**Dewey-Burdock Project  
Application for NRC  
Uranium Recovery License  
Fall River and Custer Counties,  
South Dakota**

**TECHNICAL REPORT RAI QUESTION AND  
ANSWER RESPONSES**

**February 2011**

Figure 2.7-12: Type Log Dewey Well Field #1

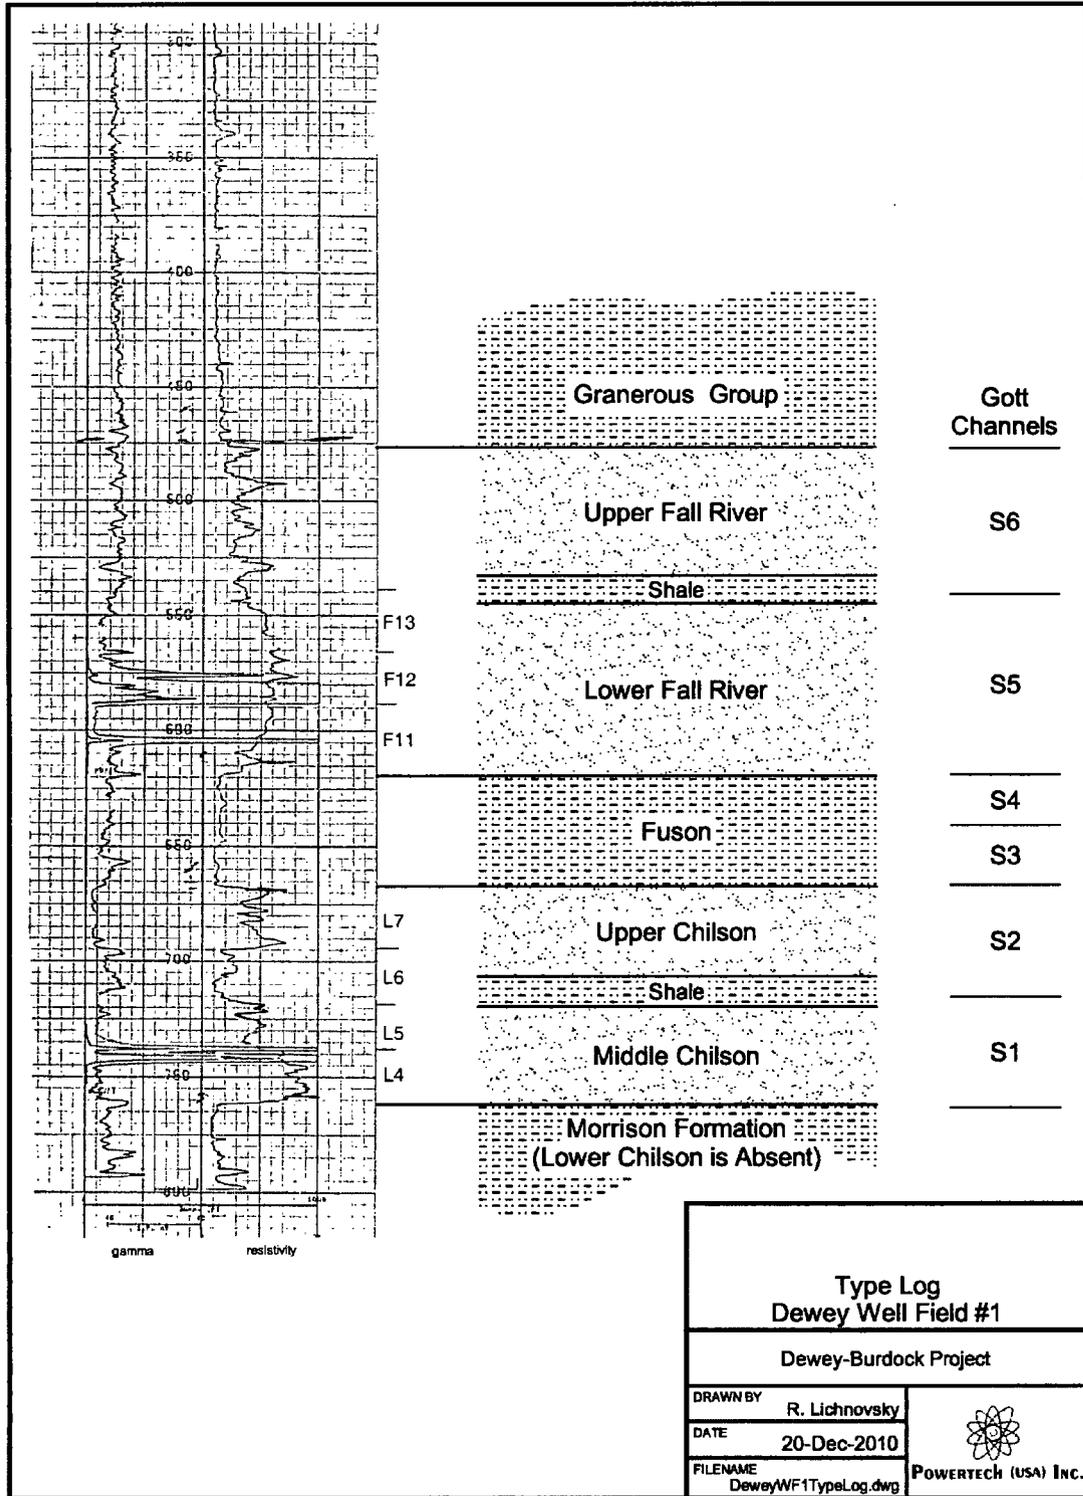
***Needed: Please re-evaluate and revise Exhibit 3.2.1 to clearly indicate the aquifer (e.g., Fall River or Lakota) that contains each ore body proposed for uranium recovery. For each well field, illustrate the scaled vertical position of each ore body proposed for uranium recovery within the aquifer that contains it.***

To better illustrate site-specific fluvial stratigraphy, representative Type Logs have been developed for the portions of the Dewey-Burdock Project where initial production is proposed. Type Logs for the Burdock Well Field I and Dewey Well Field I are illustrated in TR Figure 2.7-12 and TR Figure 2.7-13 and show a detailed view of the Fall River and Chilson aquifers, along with a scaled vertical position of each ore body proposed for uranium recovery. The locations of these Type Logs, along with the location of

**Figure 2.7-12, Type Log, Dewey Well Field I** – This Type Log shows an interbedded shale separating Upper and Lower Fall River channels. The Upper Fall River channel has poor sand development and no uranium ore bodies. The Lower Fall River channel is well developed and contains the F13, F12 and F11 ore bodies within Dewey Well Field I. A 50-foot thickness for the Fuson Member is maintained throughout the well field area. This well field is developed entirely within the Lower Fall River sand channel, but it is also important to have an understanding of the underlying stratigraphy. Upper Chilson and Middle Chilson sand channels are divided by a consistent interbedded clay unit. There is good sand development and uranium resources within both the underlying Upper and Middle Chilson aquifers beneath Dewey Well Field I, which are part of the Dewey Mine Unit III. The Lower Chilson sand channel has pinched out and is not present beneath Dewey Well Field I.

**Figure 3.1-7: Water Balances for the Dewey-Burdock Project**

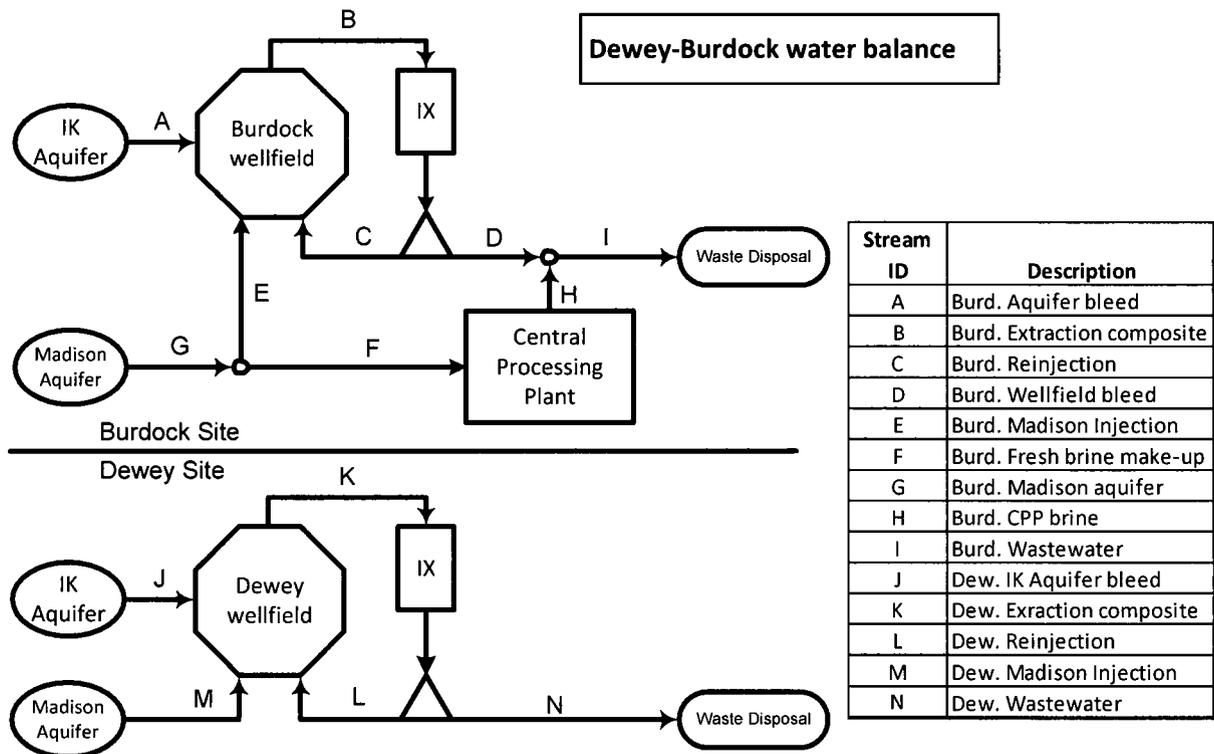
***Needed: The applicant needs to provide water balance diagrams for the Dewey and Burdock facilities during normal operation and during restoration.***

Powertech (USA) proposes two methods of wastewater disposal, Class V disposal wells and land application, that are described in detail in TR Section 6.1.9. The disposal method selected will determine the method of aquifer restoration, groundwater treatment or groundwater sweep, as described in detail in TR Section 6.1.3. In addition to these options, the PA proposes two aquifer bleed options during aquifer restoration, a 1.0 percent aquifer bleed or a one pore volume bleed, as described in detail in TR Section 6.1.3. The water balanced for both the production and the restoration phases, at both the Burdock site and the Dewey site, for these options is presented in Figure 3.1-7. Typical flow rates are provided for both the deep well disposal option, in which the groundwater treatment restoration method is utilized, and the land application disposal option, in which the groundwater sweep restoration method is utilized.

For recovery operations, the water balance flow rates are identical for both disposal options, producing, for a recovery bleed of 0.875 percent of the groundwater extraction rate, approximately 32 gpm of wastewater at the Burdock site and 15 gpm of wastewater at the Dewey site.

Figure 3.2-4: Central Processing Plant Detail

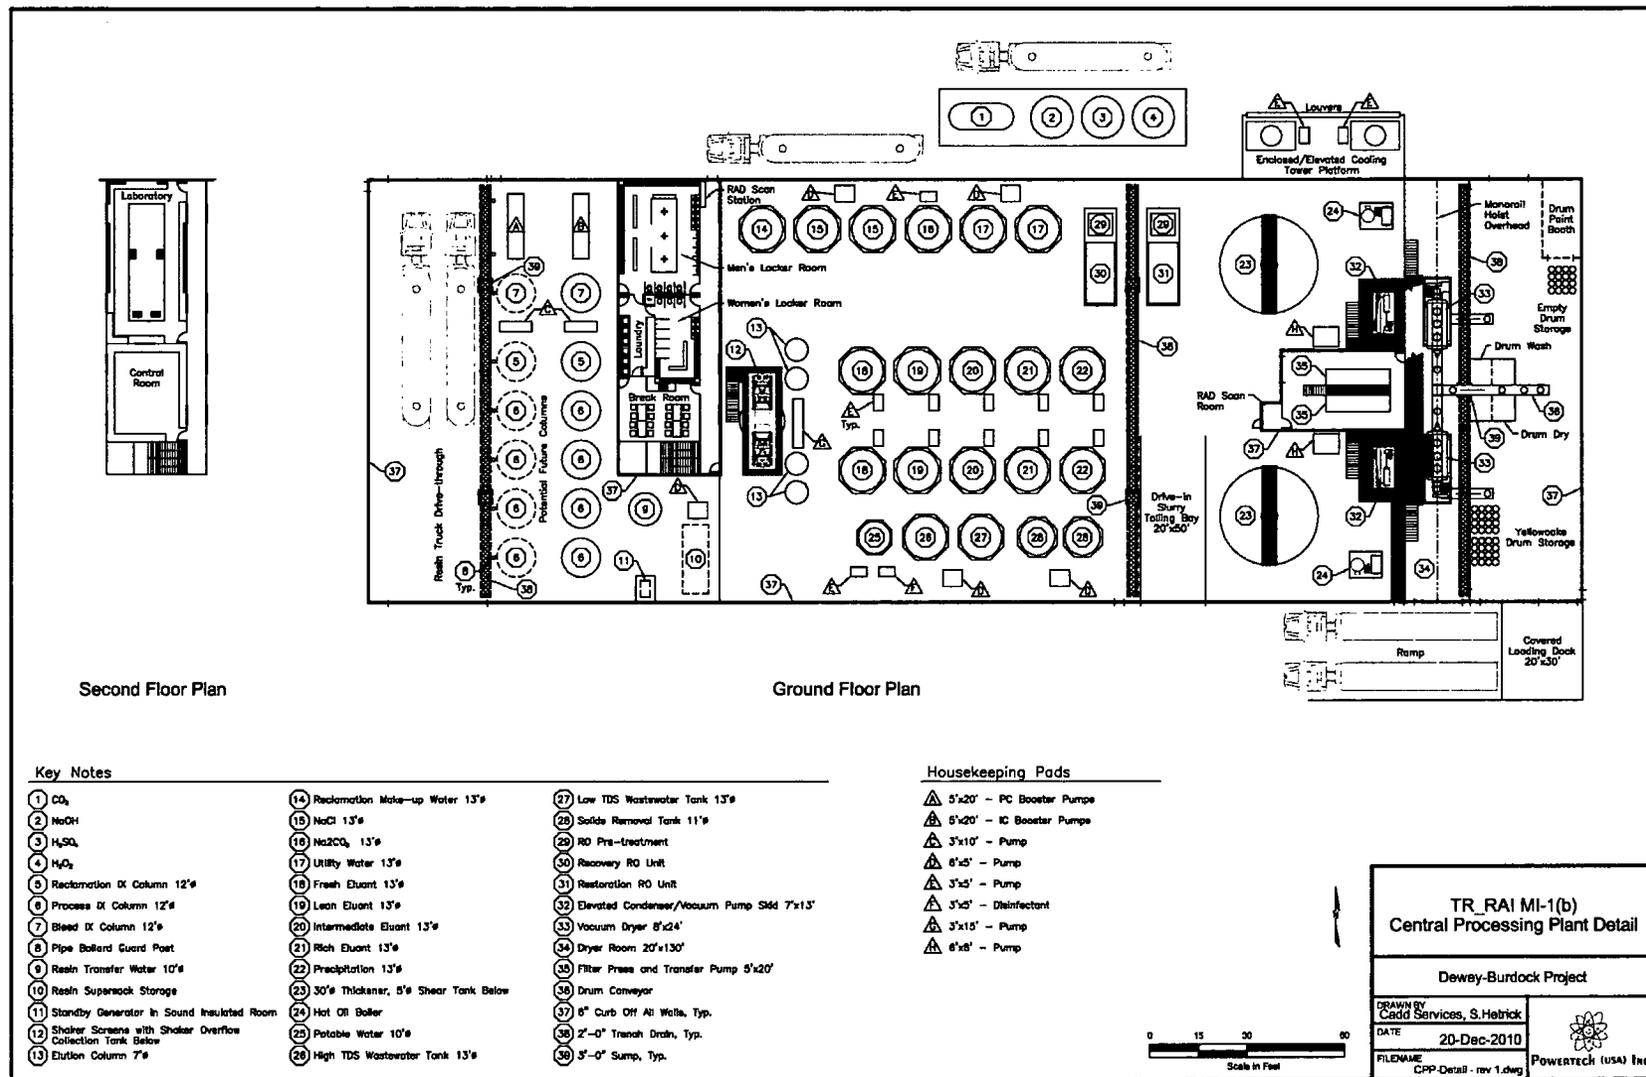
- b. The applicant needs to completely and clearly identify on Figures 3.2-4 and 3.2-5 the storage locations of all chemicals used in uranium processing (enlarge figure to be readable). The locations need to be consistent with the descriptions of chemical use provided in Section 3.2.8 of the application.*

Figures 3.2-4 and 3.2-5 are attached and show the locations of chemicals used in uranium processing.

Figure 2.7-11: Dewey Well field #1 Drainage Detail

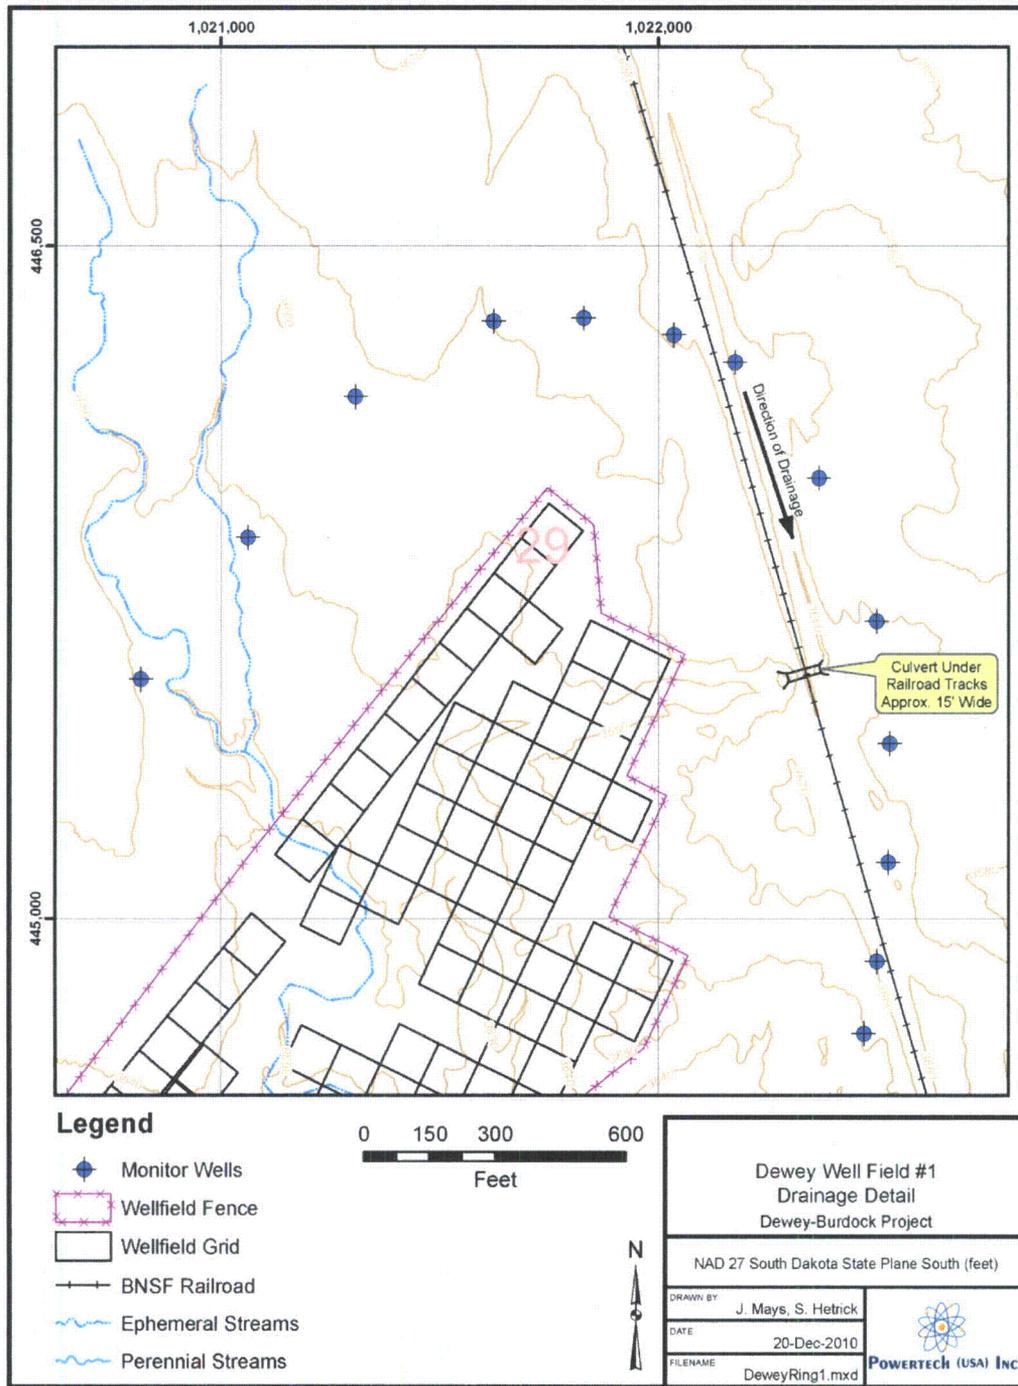
*Exhibit 3.2-1 of the TR Supplement indicated that the horizontal excursion monitoring well ring for Dewey Well field #1 is traversed by a set of railroad tracks. Staff was uncertain of the surface drainage in the topographic low areas on the northeast side of the tracks and whether the construction of the tracks includes any type of drainage system you might see for a double track construction (i.e., surface and/or subsurface drainage system). Staff is uncertain if standing water in poorly drained areas will hamper access to wells and potentially facilitate well leakage. Please clarify the surface drainage of this area.*

In Section 29, T6S, R1E, a small number of monitoring wells are proposed on the northeast side of the tracks (Exhibit 3.2-1 of the TR). The surface drainage in this area is still dominantly toward the southwest (Figure 2.7-11 below), but the raised track beds do provide some potential for standing water. The potential for collection of water is predominantly immediately adjacent to the north east side of a raised-bed for the railroad tracks. Standing water is not expected in the location of any of the monitor wells as the area is well drained in a south easterly direction along the tracks and to a culvert in the immediate vicinity.

**TR\_RAI- Figure 2.9-40(1): Plot of the equation used to determine an adequate sample size**

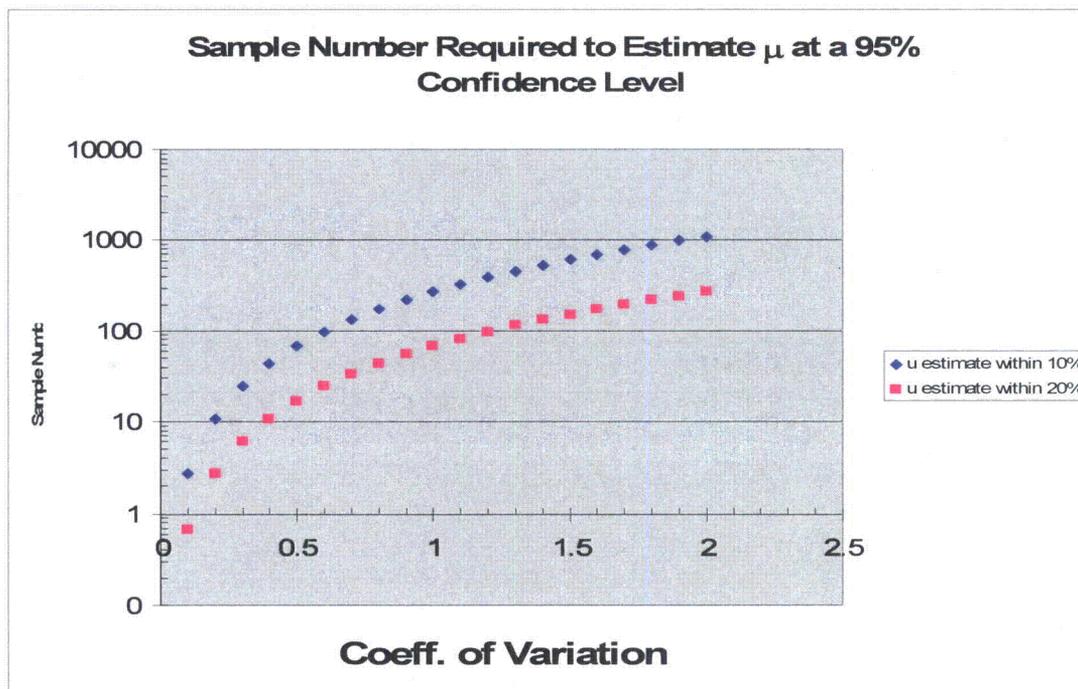
*In Section 2.9.3 of the TR, the applicant describes its soil sampling program. Figures 2.9-9 and 2.9-10 of the TR provide sampling locations from the Main Permit Area and land application areas respectively. Table 2.9-5 of the TR provides radionuclide concentrations for all soil samples. Comparing the aforementioned soil sampling data with Supplemental Exhibit 3.1-2, Proposed Facilities and Well Fields Land Application Option, NRC staff has the following questions to understand site-wide radiological variations in areas expected to be impacted by operations and evaluating compliance with 10 CFR 40, Appendix A, Criterion 7.*

The mean and standard deviation of the radium-226 concentrations in the 55 samples collected in the Main Permit Area are 1.51 and 0.77 pCi/g, respectively. The coefficient of variation for the samples is

$0.77/1.51=0.5$ . Inspection of the plot in Figure 1 indicates that about 20 and 70 samples are sufficient for collection for relative fraction errors of 10 and 20 percent, respectively. The collection of 55 samples is acceptably within this range. Therefore, we have adequately described the radium-226 concentration in the entire permit area.
